**CITY OF NOVI CITY COUNCIL
OCTOBER 14, 2024**

SUBJECT: Consideration of tentative approval of the request by Jax Kar Wash, to rezone property at the southeast corner of Twelve Mile Road and Cabaret Drive to General Business with a Planned Rezoning Overlay.

PLAN REVIEW CENTER REPORT

Rezoning Request from RC Regional Center to B-3 General Business with a Planned Rezoning Overlay

PRELIMINARY OVERALL FLOOR PLAN
 SCALE: 1/8" = 1'-0"

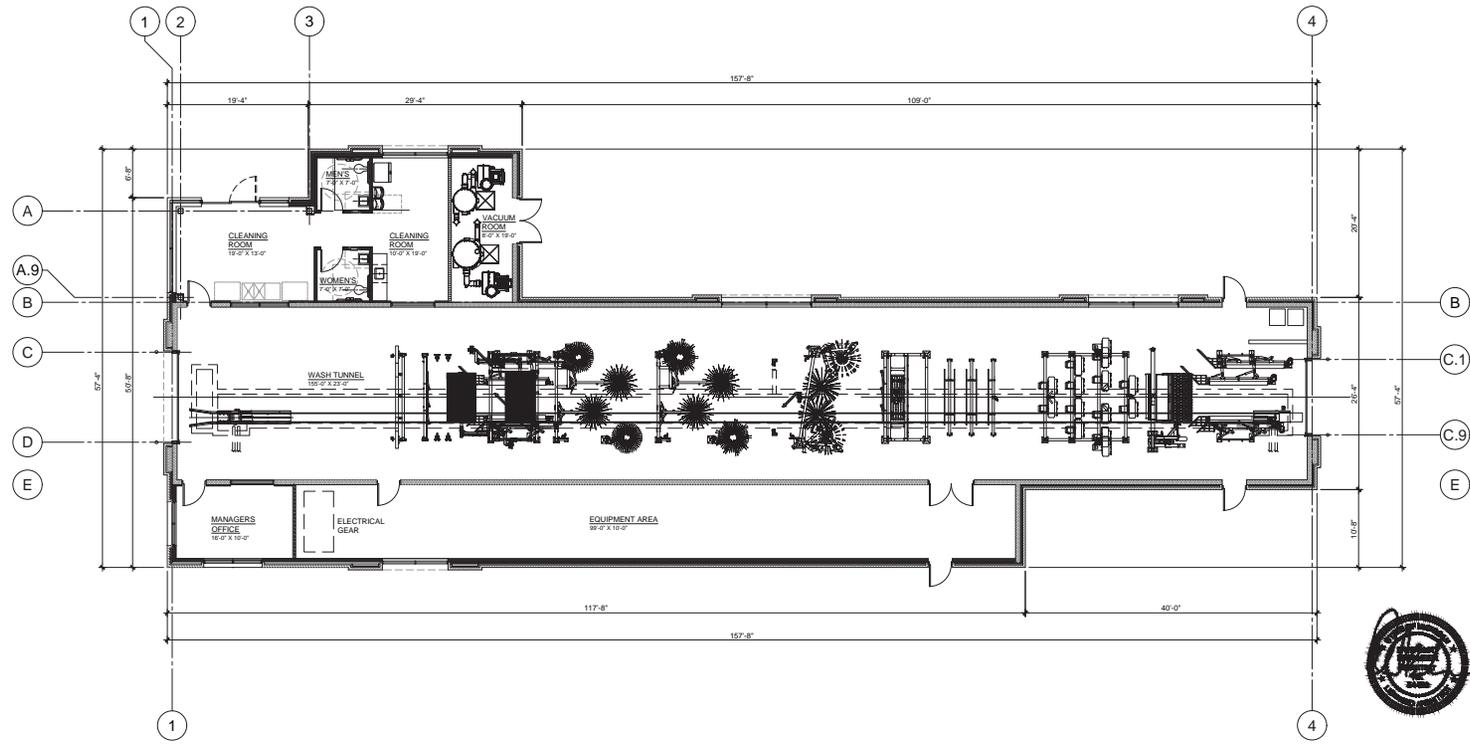
6. **Minor Revisions and Details**: Please be aware there was no revision date on the plans, the bike parking layout is not on sheet 9.0, and neither the Guard House nor the EXP structures appear on the architectural sheets. The 4000K lights on the Photometric sheet have also not been updated. The response letter indicated these items had been addressed. **If approved by Council, these items should be addressed in the site plan that gets included in the PRO Agreement.**

- The proposed vacuum system is located within the proposed building, see sheet PFP-1 Floor Plan for details. It's denoted as "Vacuum Room".

JAY CAR WASH - NOVI
PHOTOMETRIC SITE PLAN
GASSE BUSH CONTROLS
PREPARED FOR: EPD
WWW.GASSERBUSH.COM

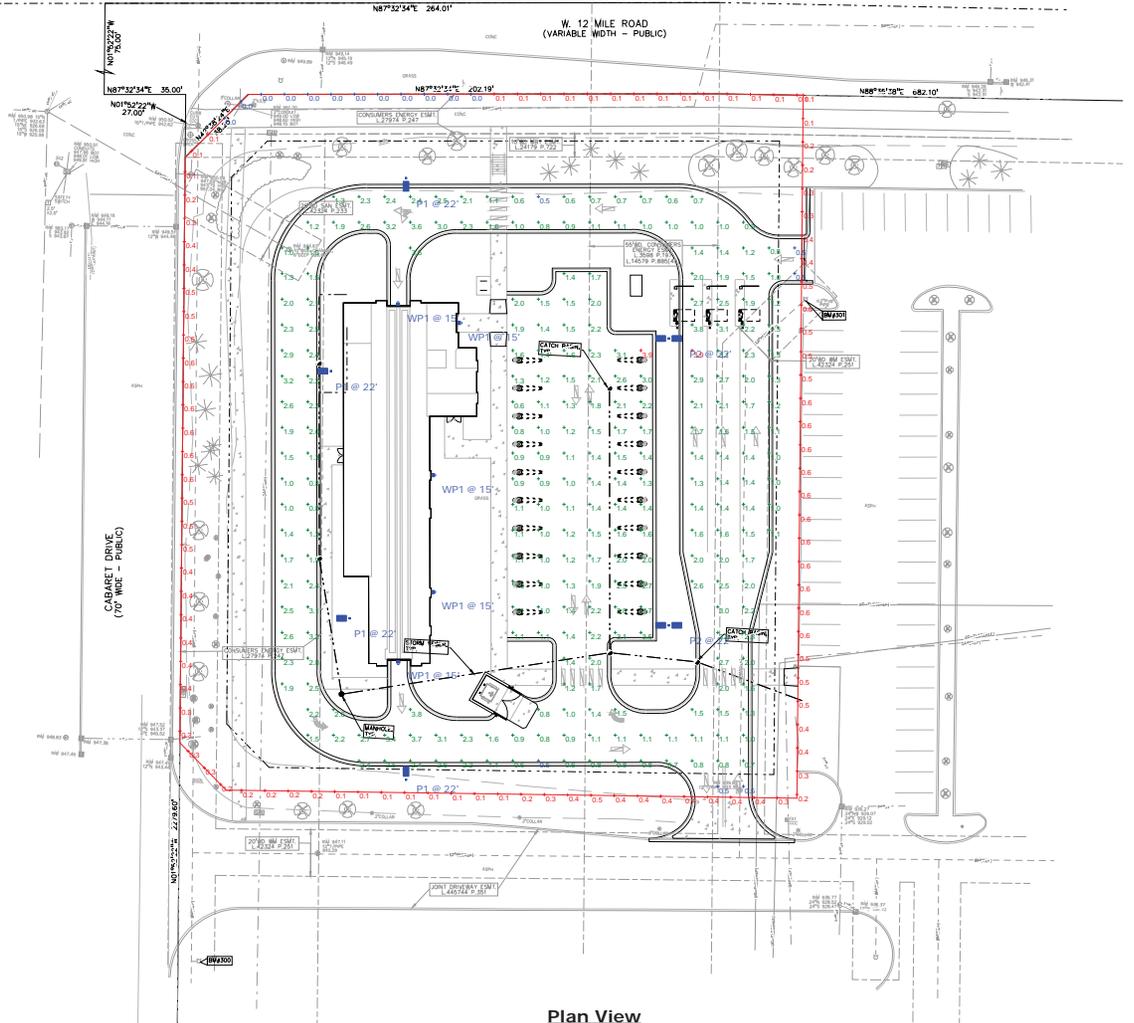
4. **Exterior lighting (Section 5.7)**: **A deviation appears to be required for exceeding the allowable Color Corrected Temperature (CCT) of 3000 Kelvin (4000K proposed). See additional lighting comments in the Plan Review chart.**
